1961 Corvette: Chevrolet Product Engineering Technical Information: Spark Plug Electrode Interference With Piston

Model and Year: 1961 Corvette Models Equipped with Fuel Injection

Source: Chevrolet Service and Mechanical Department - Technical
Information - 1961 Product Data Book

Bulletin Number: Page 3-4 - Section VI - Group 2

Reworking Piston Dome - 1961 Corvette Models Equipped
With Fuel Injection

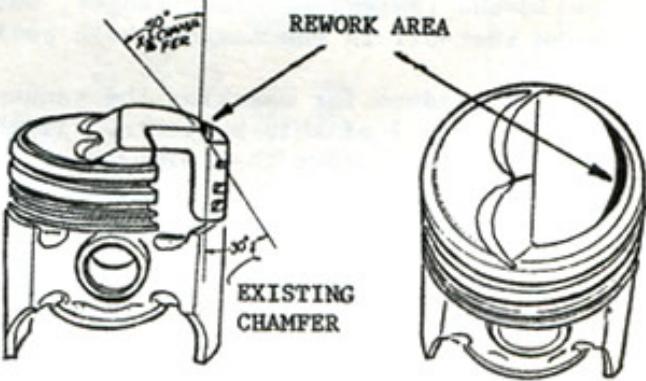
An interference condition between the spark plug ground electrode and piston dome may occur on 1961 Corvette Models equipped with fuel injection. This interference results in a bent electrode which causes insufficient spark plug gap, engine miss and subsequent poor performance.

The condition was corrected in Production effective 5-15-61 (engine date stamp F-0515) by removing 1/16" of the piston dome at the contact area as shown in the following sketch. The size of the area to be removed is approximately 1/16" thick, 1/8" wide and 1-1/2" long machined at a 50° angle. Only the top half of the dome chamfer should be removed with the lower portion remaining at the existing 30° angle.

In the event an 11:0-1 compression ratio engine equipped with fuel injection is being overhauled or if the cylinder heads are removed, each piston dome should be filed or ground off approximately 1/16" to prevent spark plug electrode interference. if only the heads are removed, the pistons should be at TDC and grease applied to the top of the pistons to insure complete remove of filings.
